Submission on Riverstone East Draft Precinct Plan

RIVERSTONE EAST PRECINCT
 ES&P INDICATIVE LAYOUT PLAN

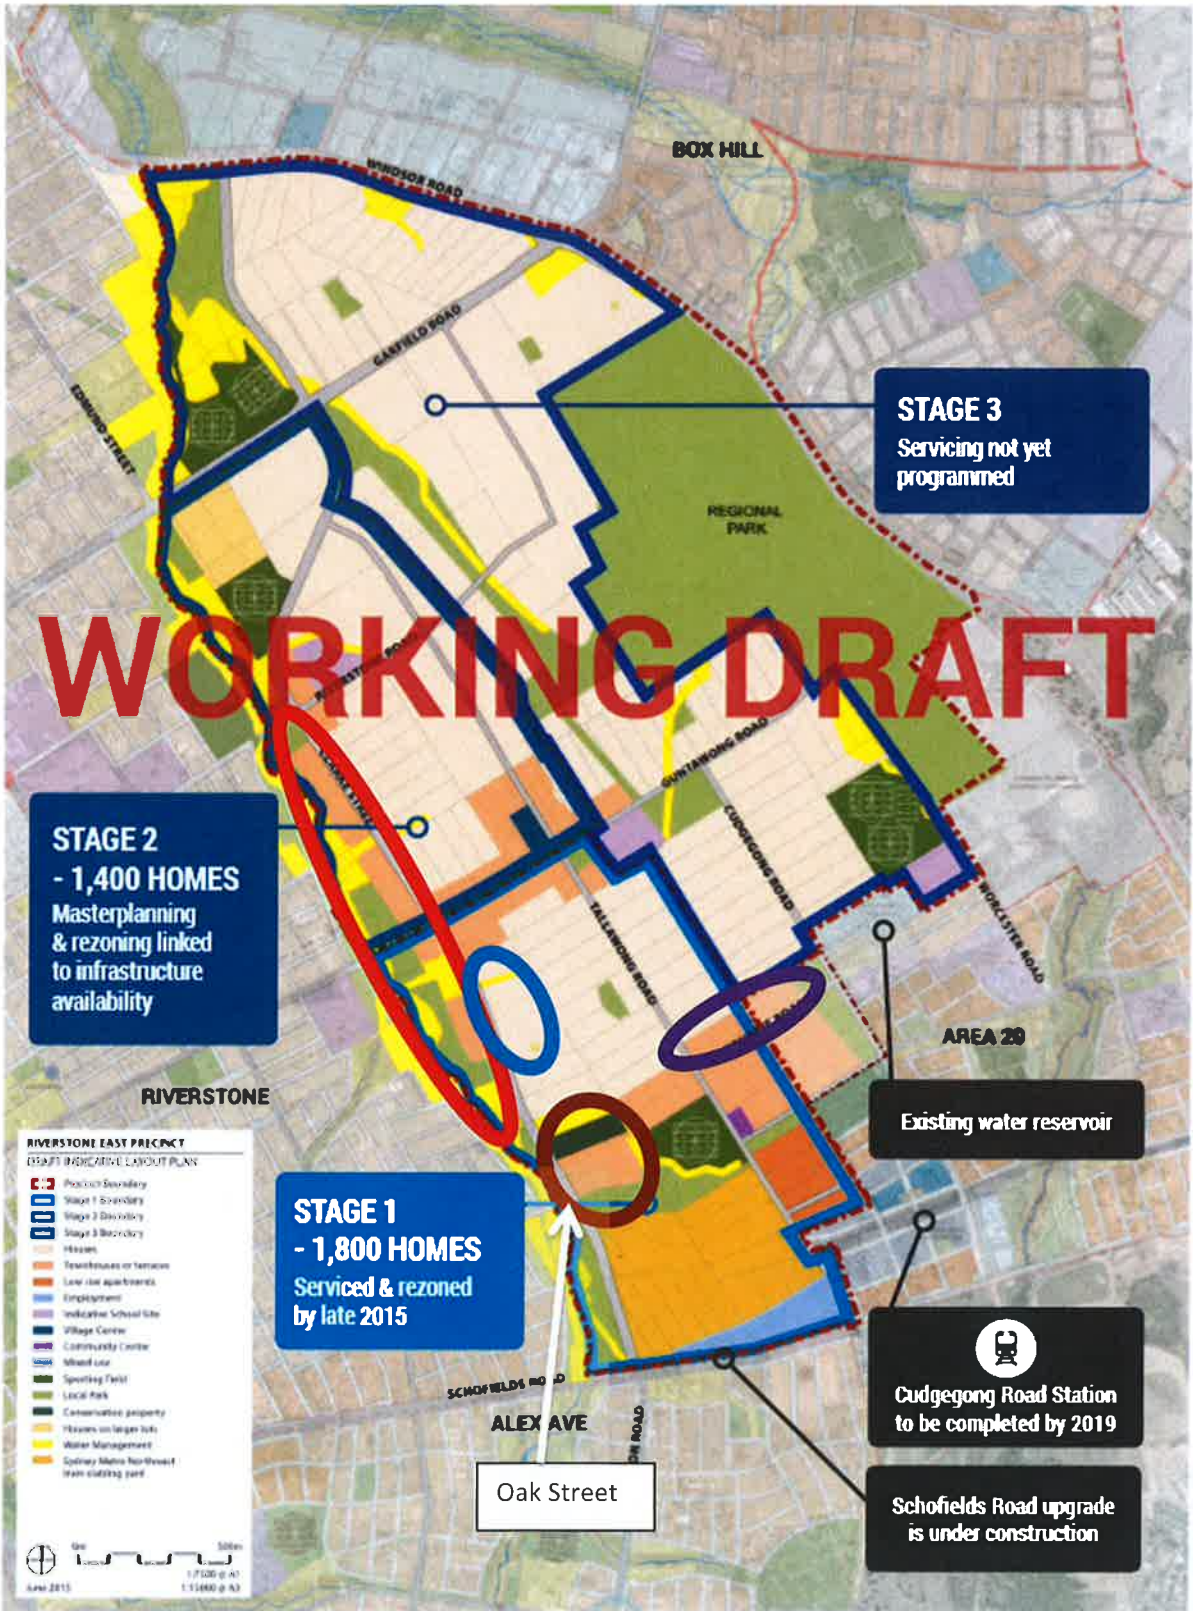
1. The proposed playing fields on Tallawong Road (87-67 Tallawong Road) will result in poor integration with the surrounding residential area as the adjoining stabling yards will significantly limit access from the south and provide little passive surveillance of the playing fields. The stabling yards are substantially elevated above the proposed playing fields and the only building between it and the playing fields will be a substation. Both of these characteristics will mean that there will be little passive surveillance of the playing fields. This will result in the playing fields not realising their full potential and attracting undesirable behaviour. Better land use and open space planning outcomes would be achieved if the playing fields were surrounded by a predominantly residential area and not adjoining the stabling yards.

Further, this land (87-67 Tallawong Road) is within 800m of the new Cudgegong Road Railway Station and should be zoned for medium density residential use with a road between it and the stabling yards.

3. The proposed R3 Medium Density Residential zone along Clarke Street (refer to red and brown circles on attached map) and north of Macquarie Street does not make sense (refer to purple circle on attached map). Neither of these areas are within walking distance (800m) of the new Cudgegong Road Railway Station and some are quite isolated and inconsistent with proposed surrounding land uses (e.g. the land on Oak Street) (refer to the brown circle on attached map).
